STAFF REPORT
COTTAGE GROVE CHEVROLET
MODIFICATION TO APPROVAL MTA 1-22
4,200 SF ADDITION TO VEHICLE SERVICE CENTER
March 16, 2022

MEMO

Subject: ENGINEERING COMMENTS FOR SDR 1-22 (2775 ROW RIVER ROAD – COTTAGE GROVE CHEVROLET)

SITE GRADE DRAINAGE PLAN

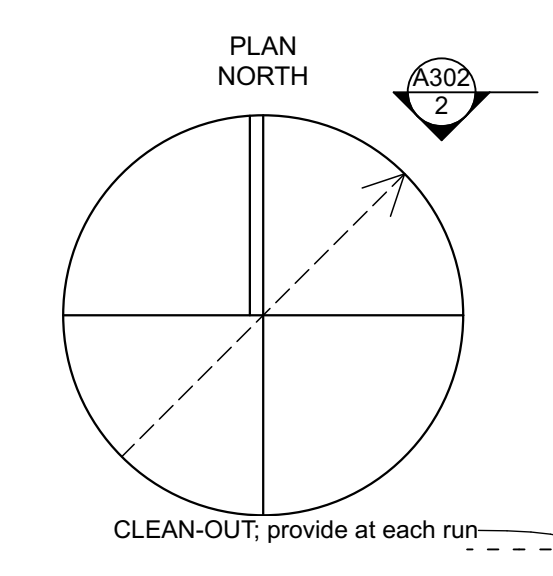
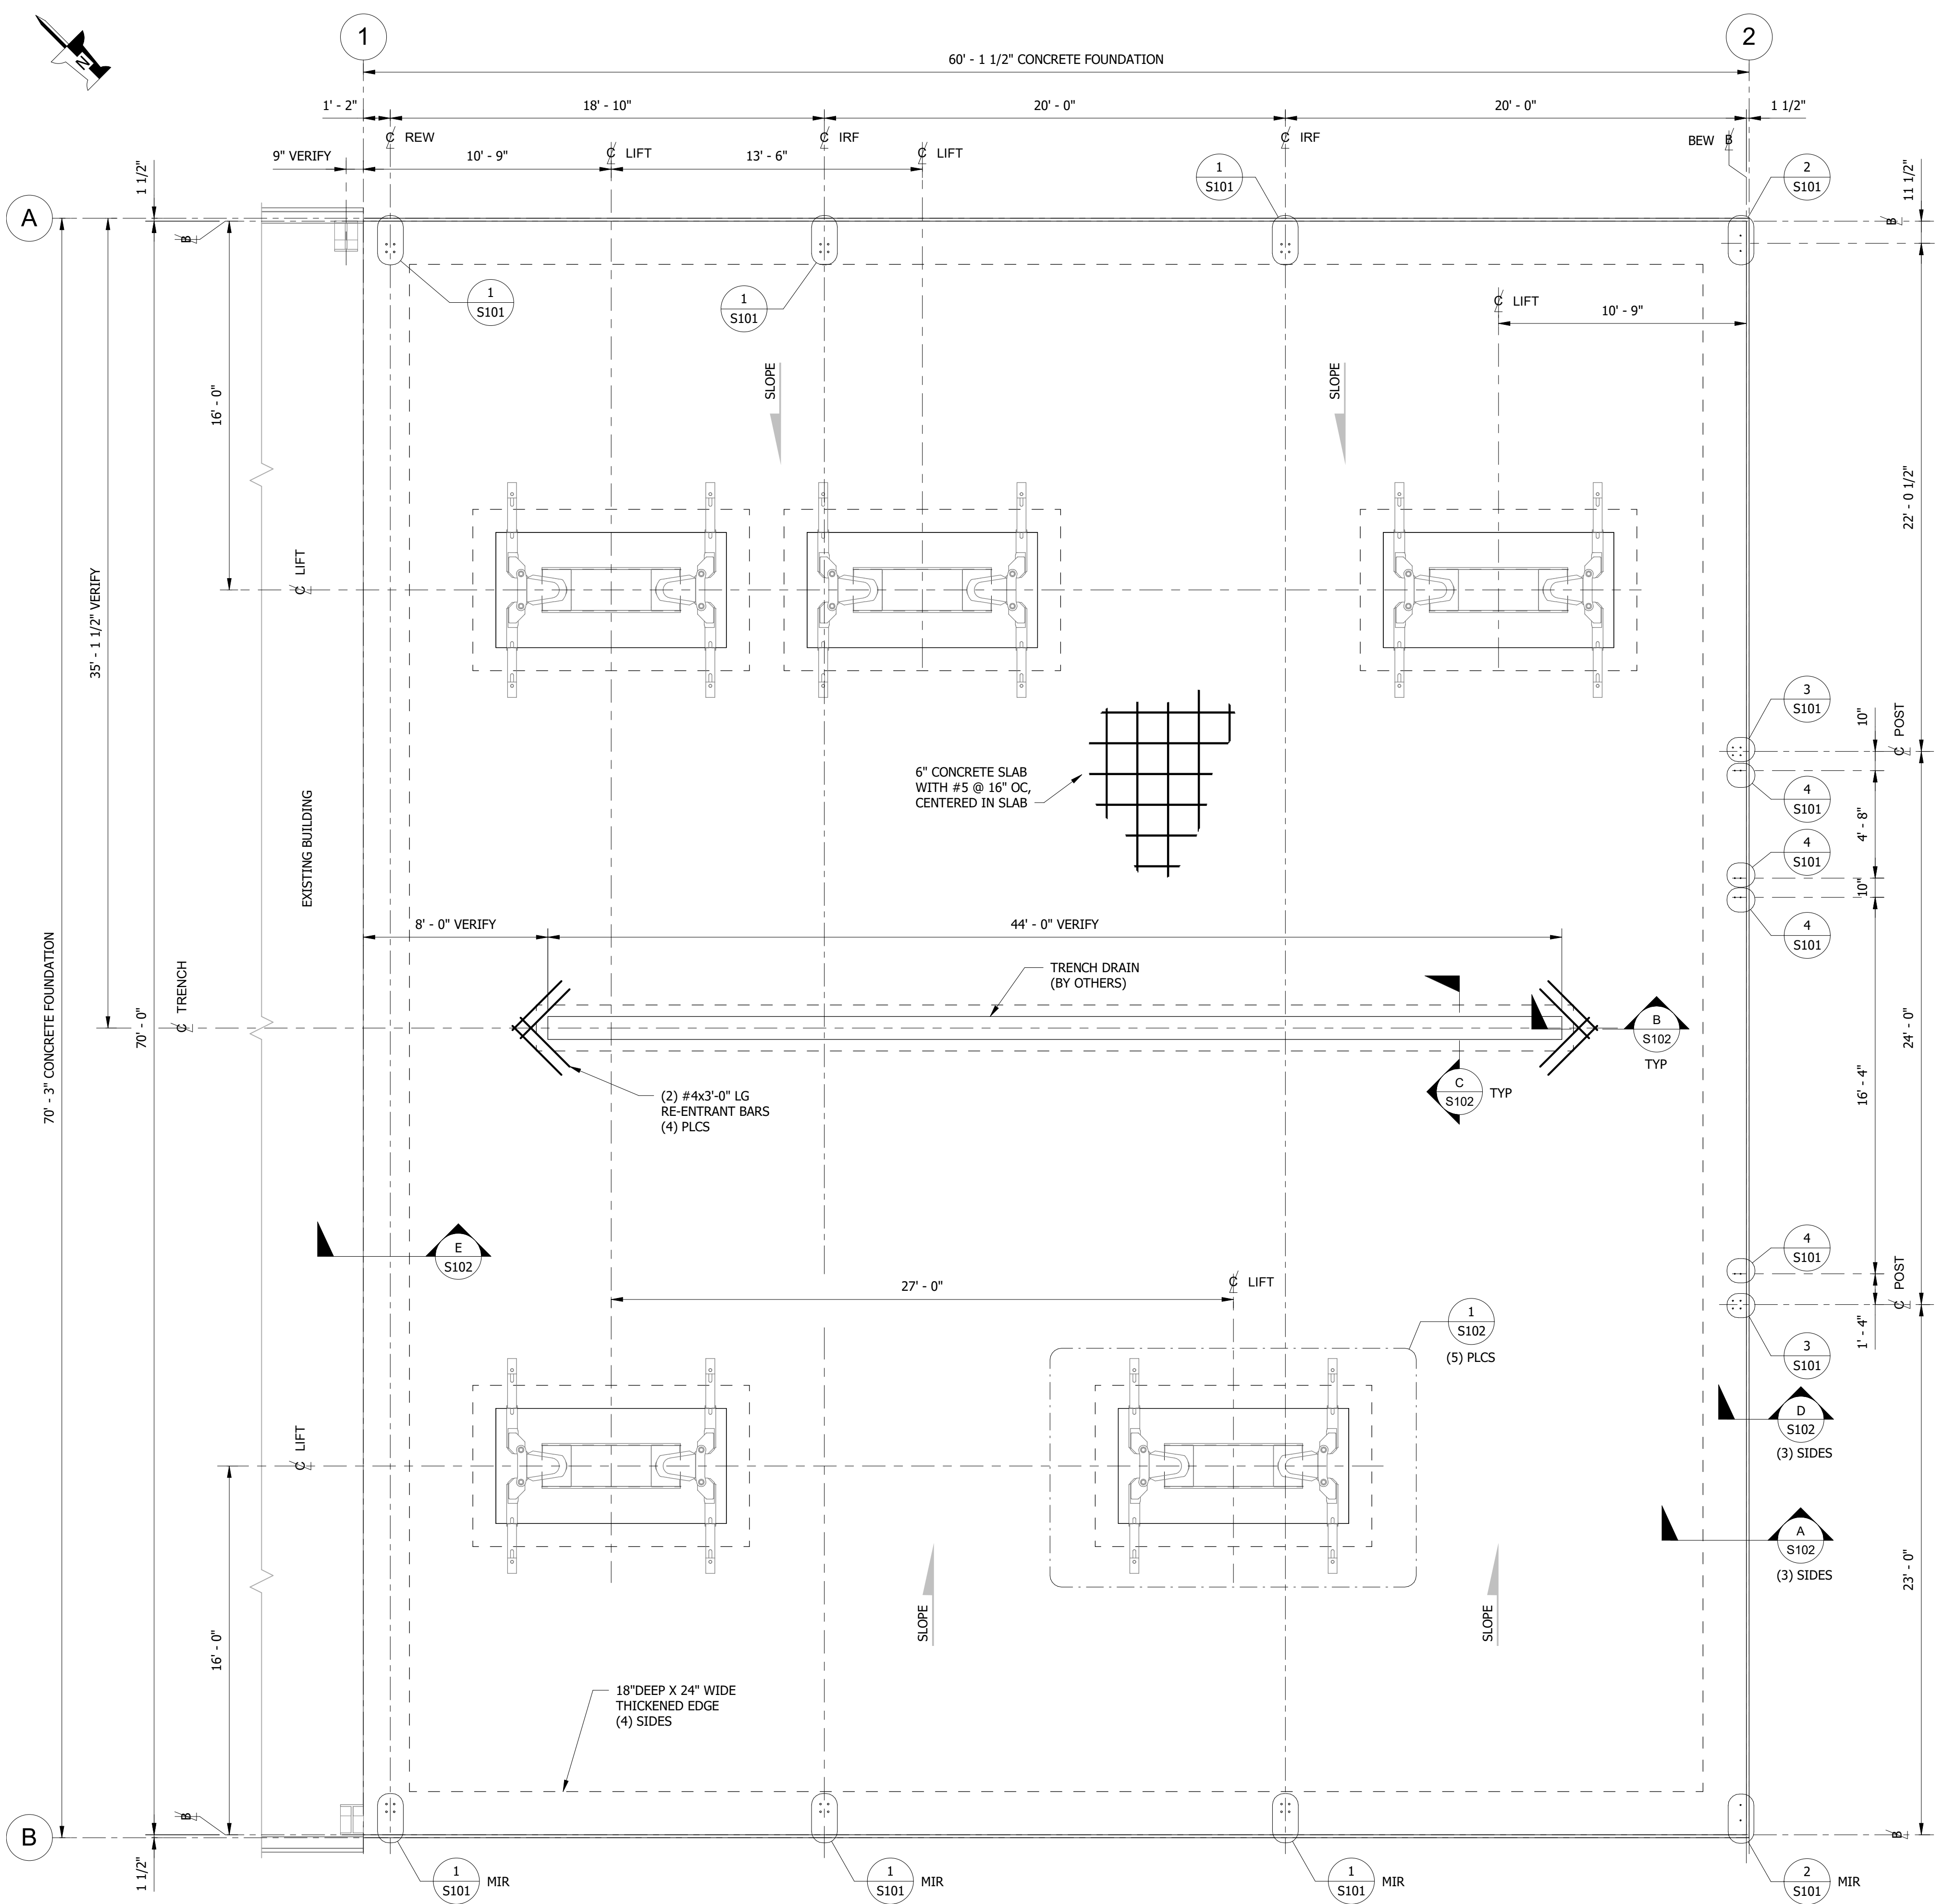
- An 8-inch sanitary sewer serves the property currently off Mosby Creek Road.
- Effluent from the Oil/Water Separator needs to drain to the sanitary sewer.
- Is the trench drain and collector box inside the new addition connected to the oil/water separator? I did not see any connection between the two in the plans.
- I am having difficulty understanding how the oil in the water is going to gathered. From the detail from Gibson Steel, it appears that outlet of the structure is below the level of the absorbant pouches. The proposed structure is great for removing sediment. Designer should verify that this particular structure should be used in this situation.

- From the detail on Sheet 105, half of the separator structure has a grate on it. From the location shown on the plans, this is not acceptable. Storm water cannot get into the structure and go to the sanitary sewer. The City of Cottage Grove has separated the storm water and sanitary sewer infrastructures and is actively separating any cross connections. .
- Storm water runoff is not to adversely affect adjacent property owners; therefore no overland flow is allowed. All storm water runoff from this development shall be contained on the property prior to connecting the public storm drainage system.
- Any on site catch basins shall comply with the latest version of by the Oregon Plumbing Speciality Code.
- No hydraulic calculations are needed because the existing conditions are a paved parking lot, so there will be no increase in storm water runoff from the proposed development.
